Re: Coors Village/ 4500 Quaker Hights NW
Request for Certificate of Occupancy
Transportation Development Final Inspection
Engineer's Stamp dated 09-23-24 (F11-D019A)
Certification dated 02-06-25

RE: APPROVED SITE PLAN FOR BUILDING PERMIT

REQUEST FOR PERMANENT CERTIFICATE OF OCCUPANCY

COORS VILLAGE, 4500 QUAKER HEIGHTS NW, ALBUQUERQUE, NM 87120

REVISIONS	
	TRACT 3A COORS VIILLAGE	DRAWN BY RMG
多	4500 QUAKER HEIGHTS ABQ NM 87120	<i>DATE</i> 09/23/2024
1 1	SITE PLAN FOR BUILDING PERMIT	2019064_SP
KEER		SHEET #
2024	TIERRA WEST, LLC 5571 MIDWAY PARK PLACE NE ALBUQUERQUE, NM 87109	C1
ANNAN	(505) 858-3100 www.tierrawestllc.com	јов # 2024019

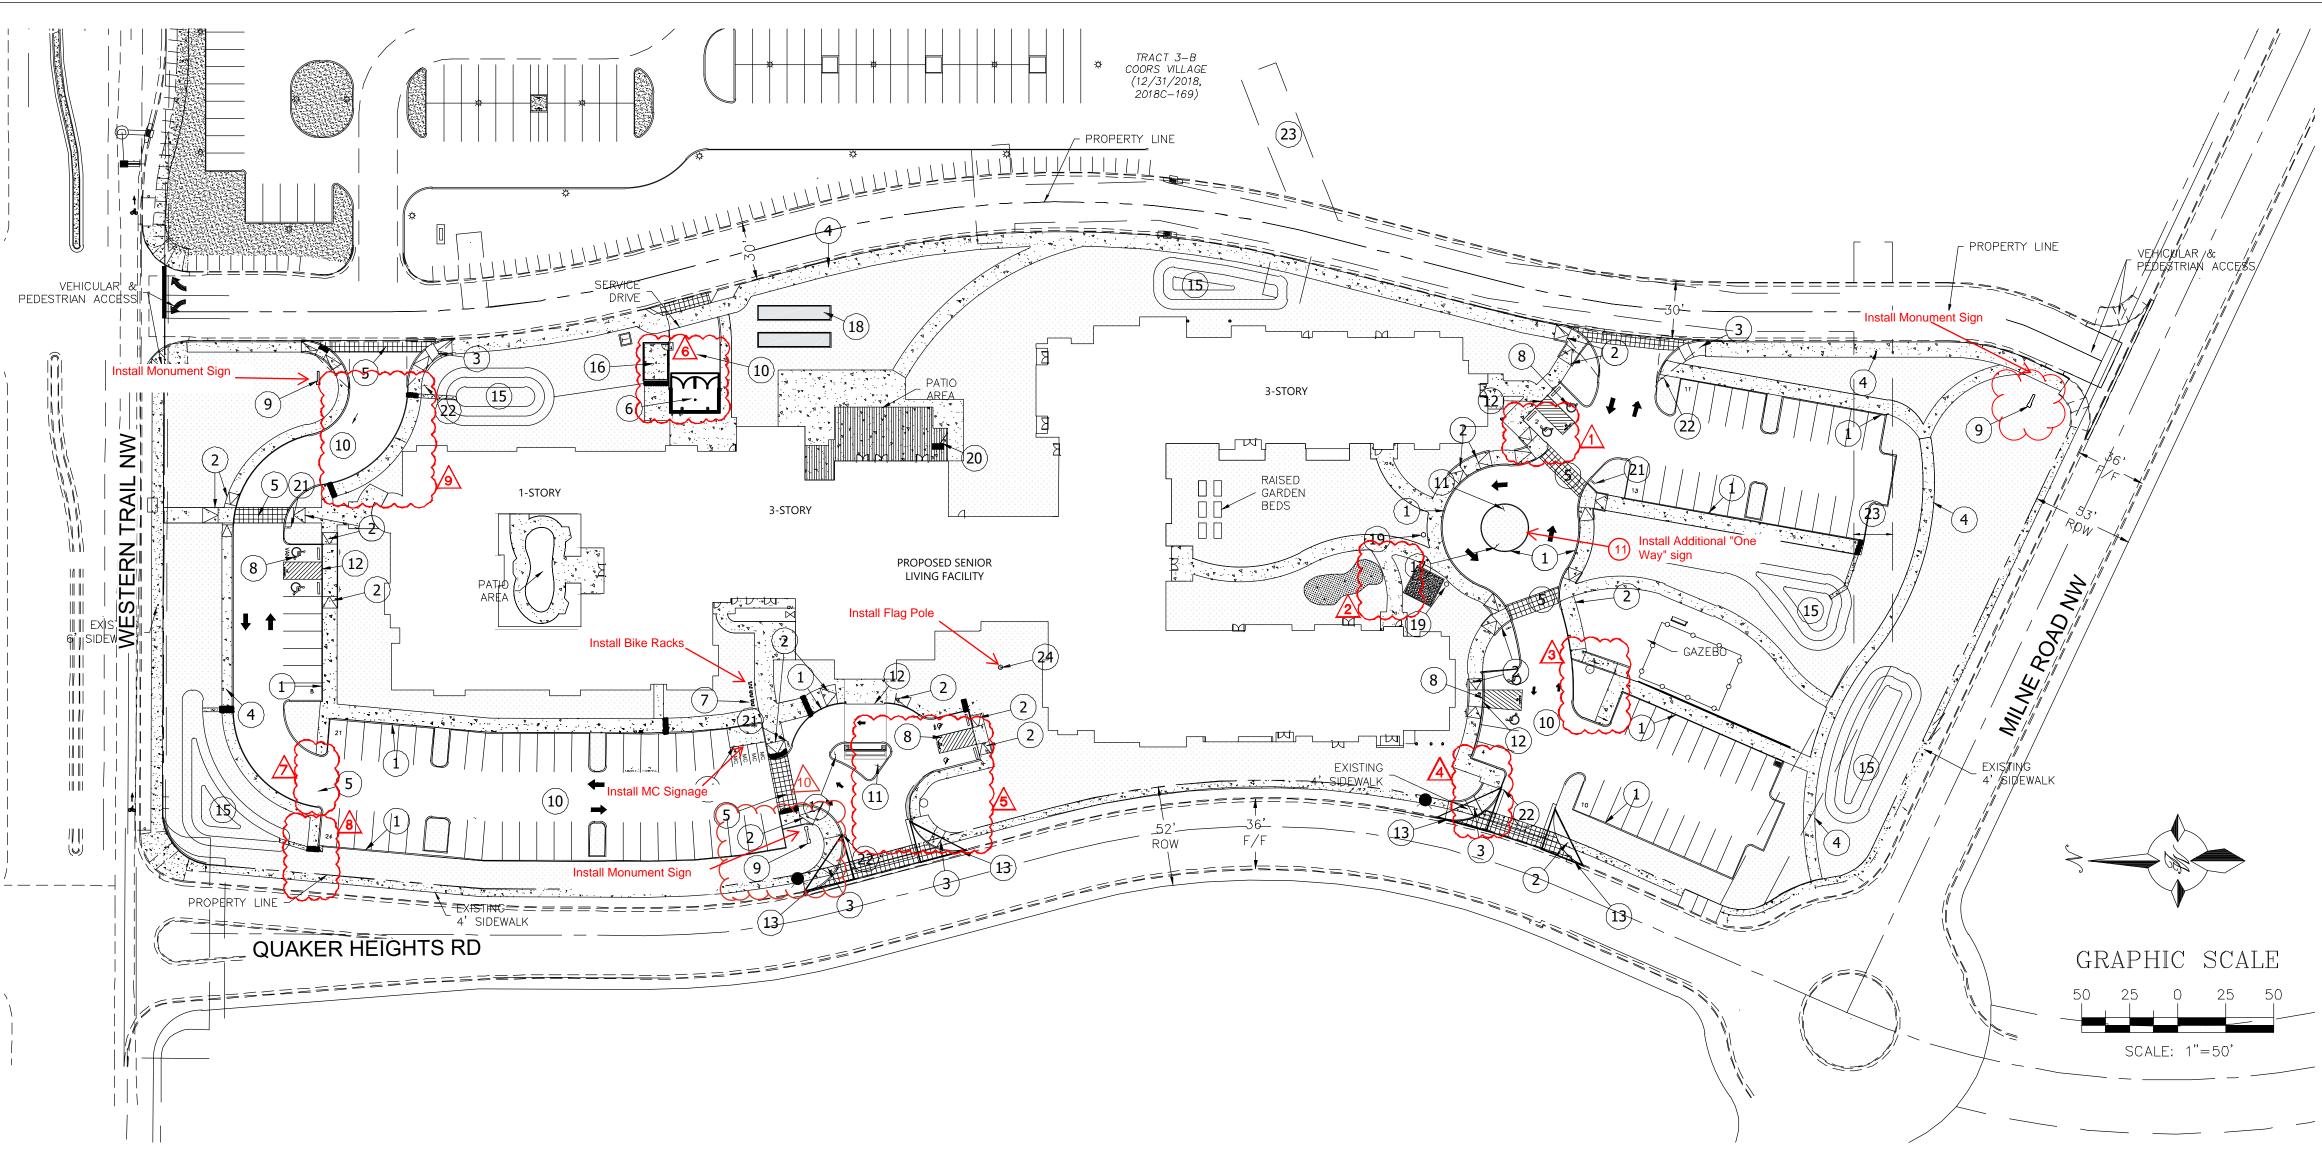
Site Plan Certification Punchlist 1) Install Flag pole 2) Install Bike Racks 3) Install Additional One Way sign at Roundabout 4) Install Monument Signage

MONUMENT SIGN -ELEVATIONS & PLANS

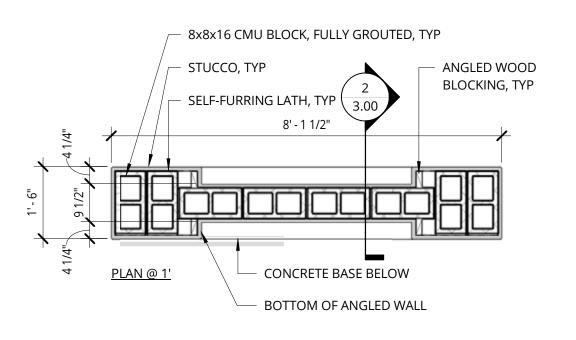
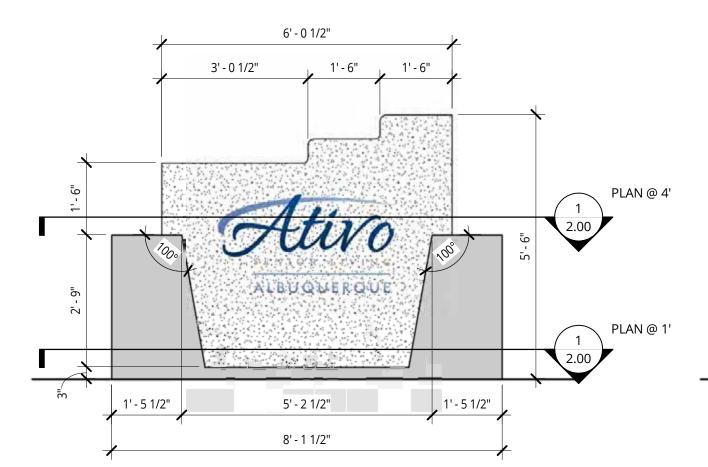
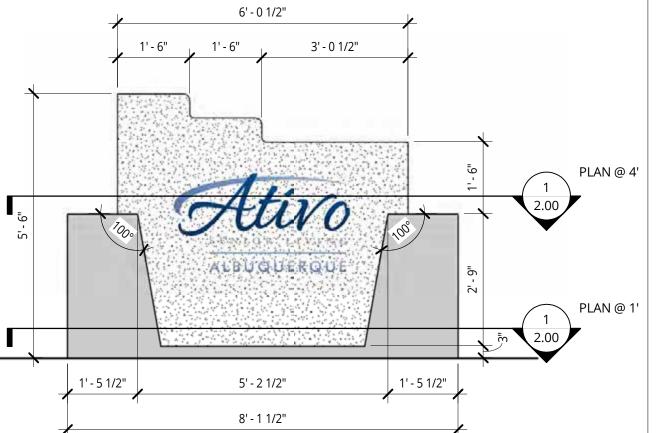
We may need to update due to design

APPROVED Monument Sign
